PCN-20231016 KK0714-02 to KK0714-04 Hardware Revision Change

Company	Trenz Electronic GmbH
PCN Number	PCN-20231016
Title	KK0714-02 to KK0714-04 Hardware Revision Change
Subject	Hardware Revision Change
Issue Date	2023-11-06

#1 Changed milled height profile.

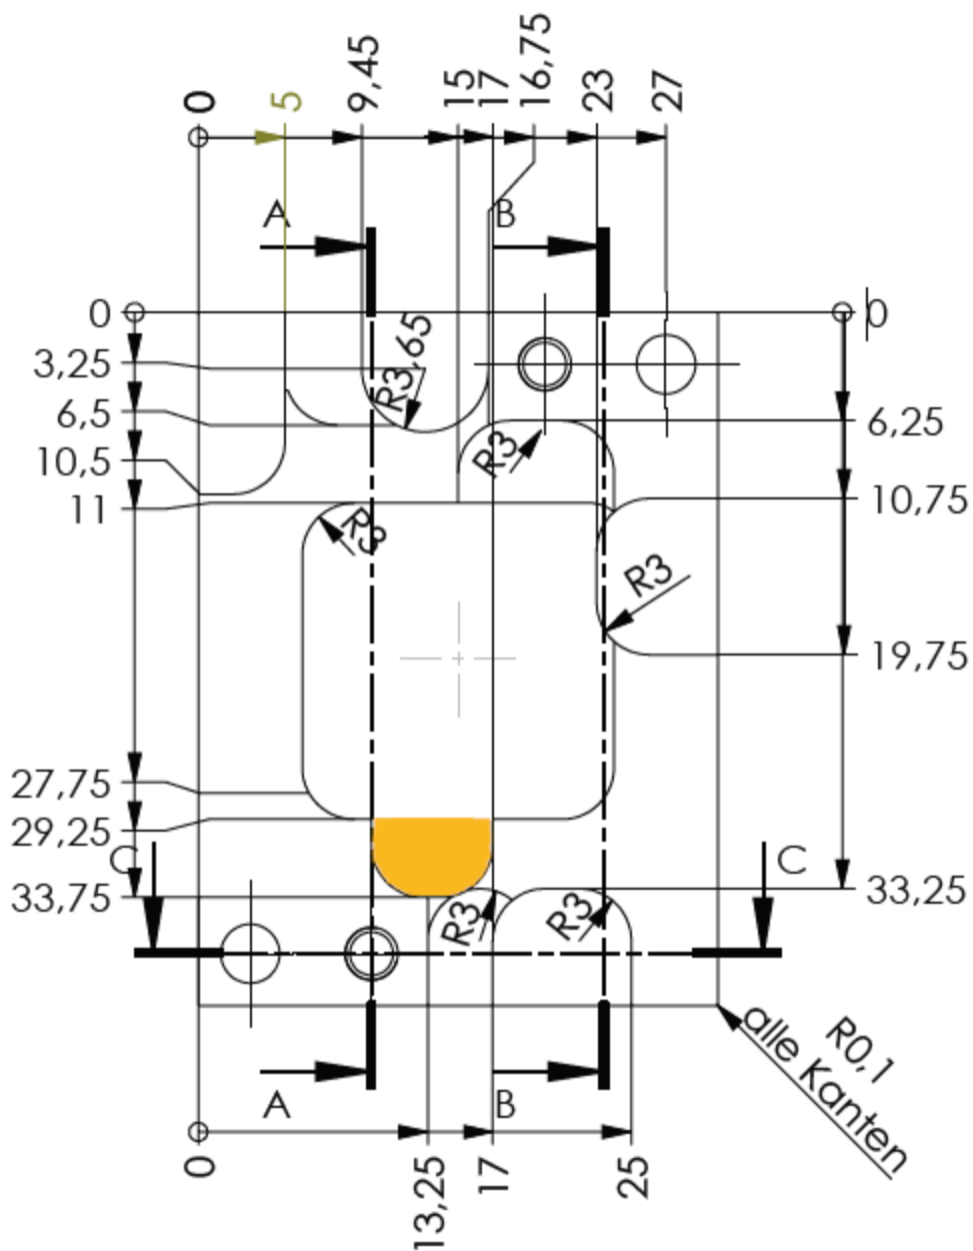
Reason: Revision 04 of TE0714 has different skyline and is therefore mechanical not compatible with KK0714-02.

Impact: New heat spreader is compatible with TE0714-04, and also backwards compatible to older versions of TE0714.

Models with the feature marked in yellow are revision 04. Heatspreader without that feature are of older revision and not compatible to TE0714-04.
